WLTP

Comparison of WLTP unified database distributions and WLTC rev2 distributions

Heinz Steven

08.10.2011

Figure 6

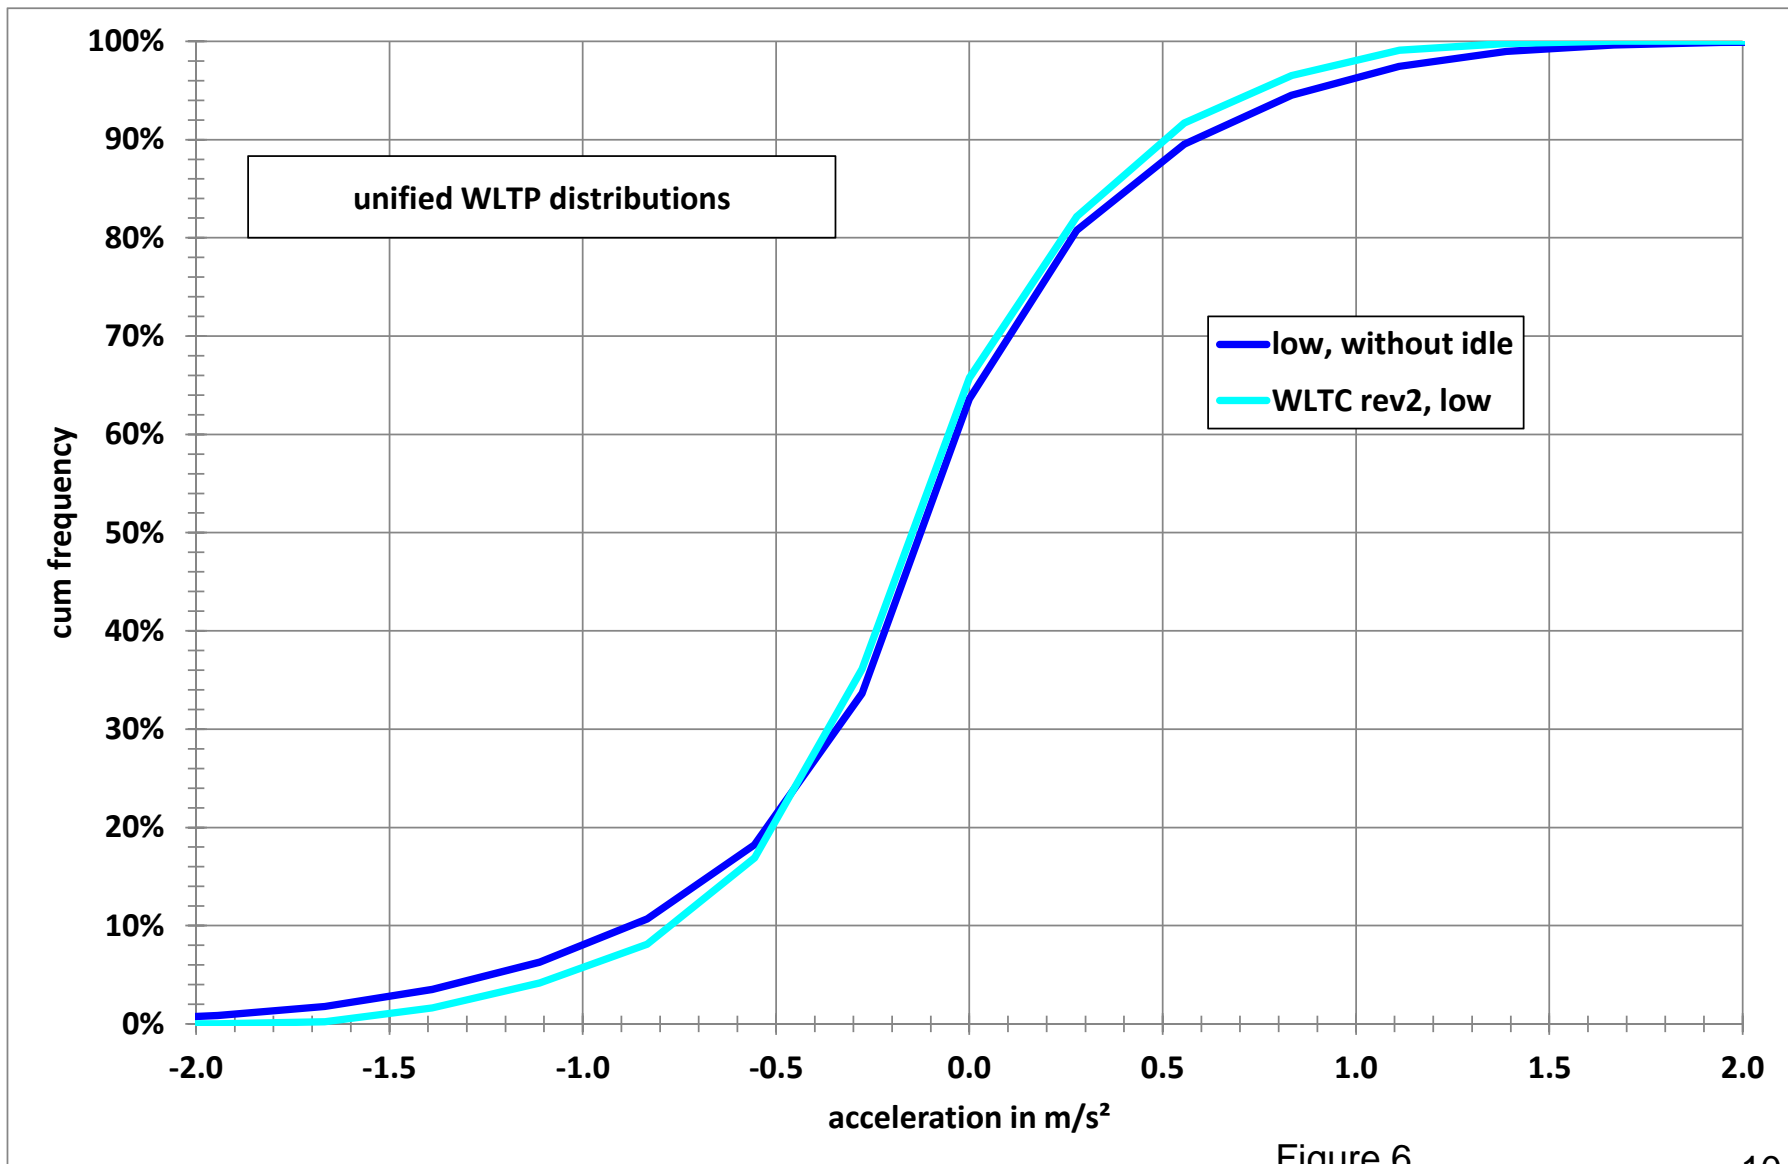
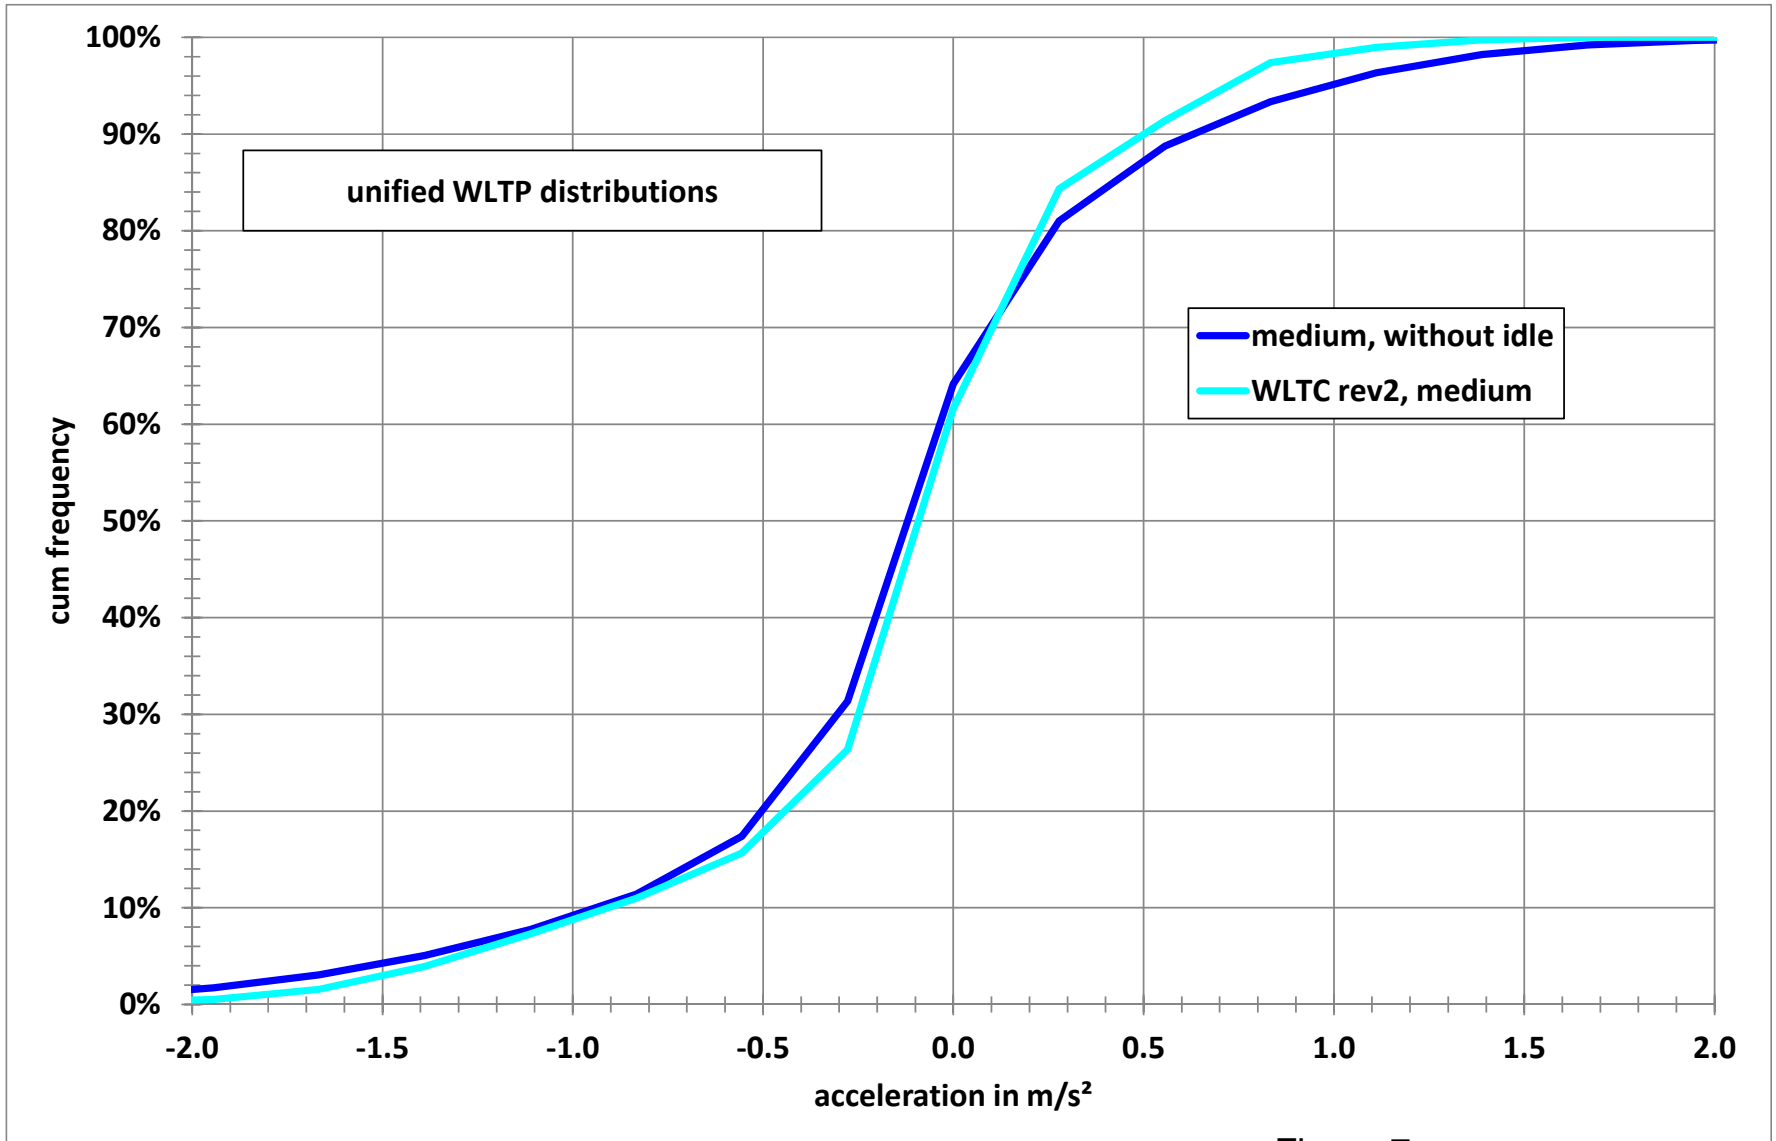
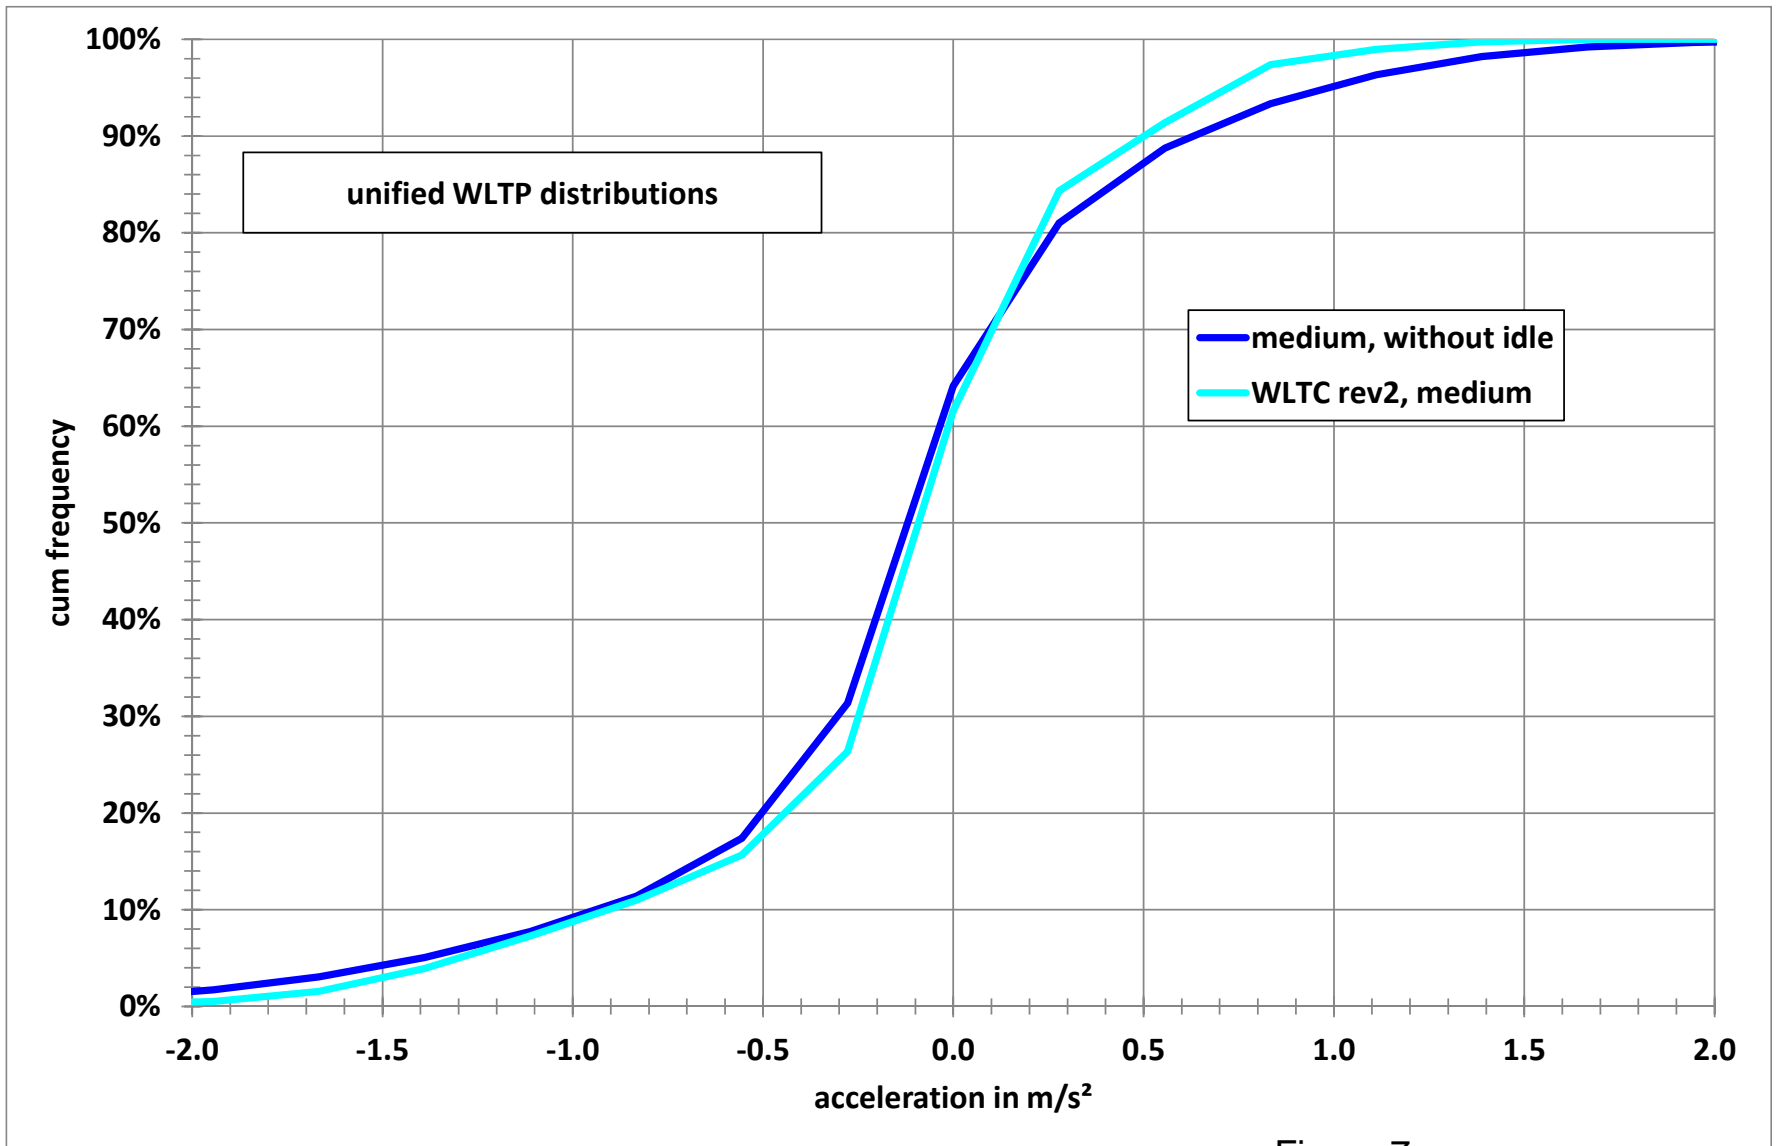
- This situation is unsatisfactory, especially because the acceleration phases determine the major parts of the CO₂ and NO_x emissions in real traffic.
- Figure 5 shows results of PEMS measurements performed with 3 different EURO 4 Diesel vehicles in Stuttgart within a project sponsored by LUBW.
- The routes driven were related to the low speed part. The idling and deceleration phases determine about 10% of CO₂ and NO_x emissions each, the by far most important phase is the acceleration phase.
- In this context, the situation will not be improved enough, if the idling phases are disregarded for the analysis (see figures 6 and 7).
